City of Fort Bragg

Administrative Public Hearing for Minor Use Permit (MUP 3-21)

Receive Report, Conduct a Public Hearing and Consider Approval of Minor Use Permit (MUP 3-21) to Construct a 900 Square Foot Accessory Dwelling Above a 2 Car Garage in the Medium Density (RM) Residential Zoning

APPLICATION NO.: Minor Use Permit 3-21 (MUP 3-21)

Figure 4 East Elevation

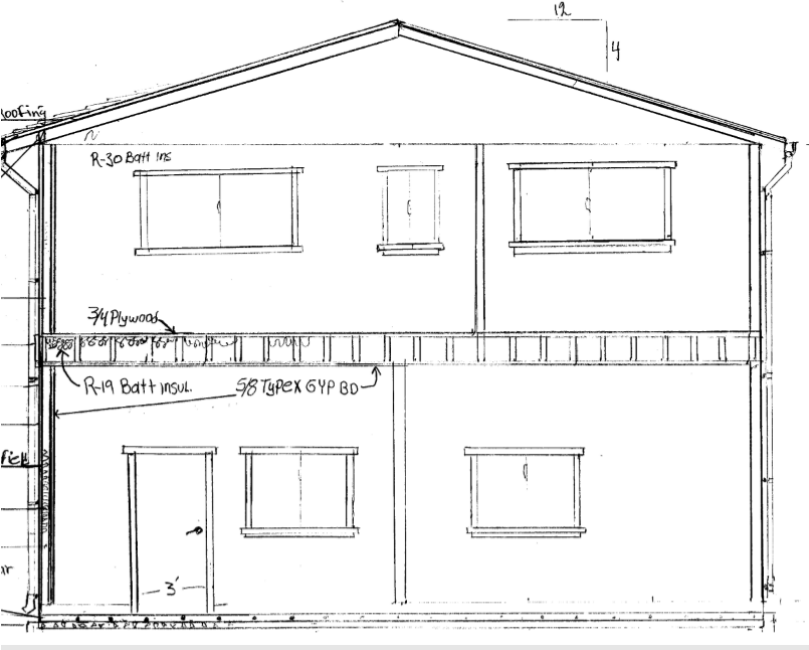
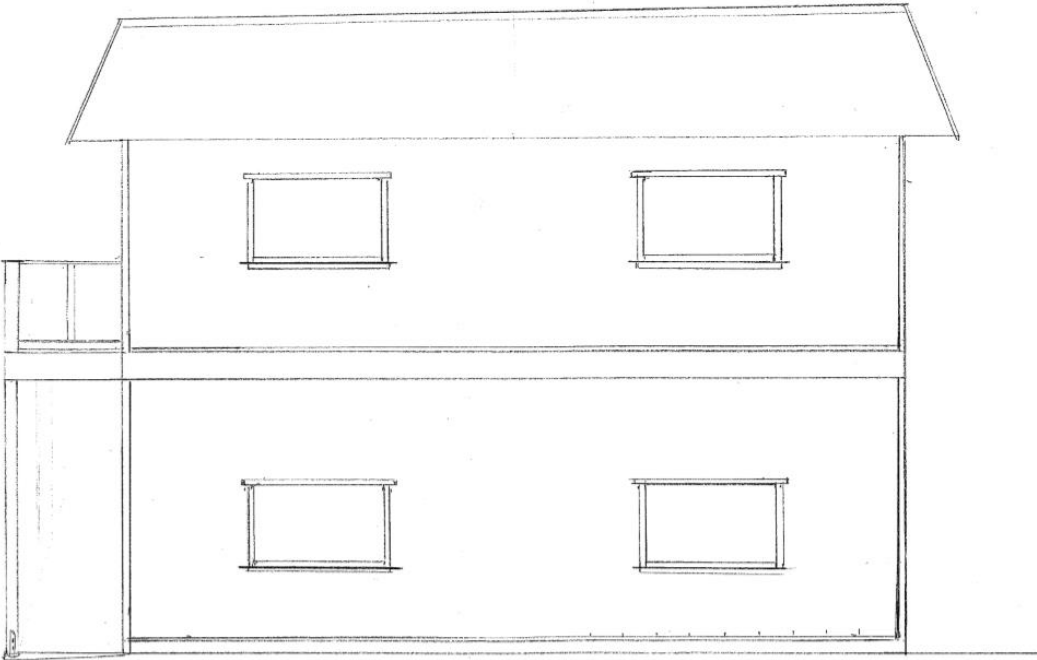
Should the decision maker determine that the window staggering is insufficient or further wish to eliminate or rearrange the window configurations shown in Figure 4

and Figure 5 above a supplemental special condition may be selected (Special Condition 1 or 2).

We are concerned about the windows on the Upper Floor East Side and North side both of which have an unobstructed view of our back yard eliminating all privacy.

1. The applicant shall revise their plans to install clerestory windows on the northern and southern elevations; or
2. The applicant shall revise the window orientation to remove one second story window from each the south elevation and north elevation to allow future potential upward ADU growth on neighboring parcels to enjoy similar number/size of windows with staggering.

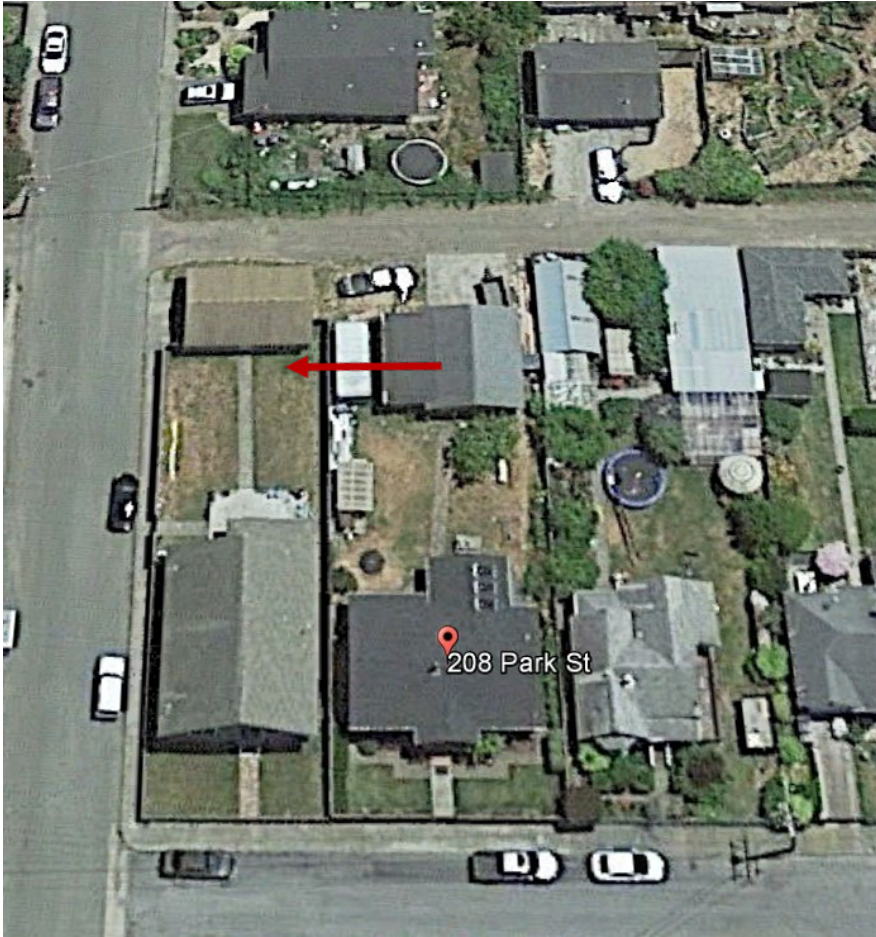
See the attached window analysis from two recent second story ADU MUP applications. This type of visual analysis is missing from the staff report and agenda materials for MUP 3-21. In light of the staff recommendation to further shift the proposed second story ADU eastward five additional feet from the location proposed by the applicant in response to neighborhood compatibility concerns raised in the written request for a public hearing, this type of "neighboring yard" window placement analysis is even more necessary for the review for MUP 3-21 to evaluate the window placement for the northern and southern elevations of the proposed second story ADU. I recommend that it be prepared and presented during the administrative public hearing to ensure that no windows directly overlook any of the rear or side yard areas on the neighboring lots.

Staff determined window placement looked directly into neighboring yard

Staff determined windows looked directly onto roof of neighboring structure to south, and parking area to the north
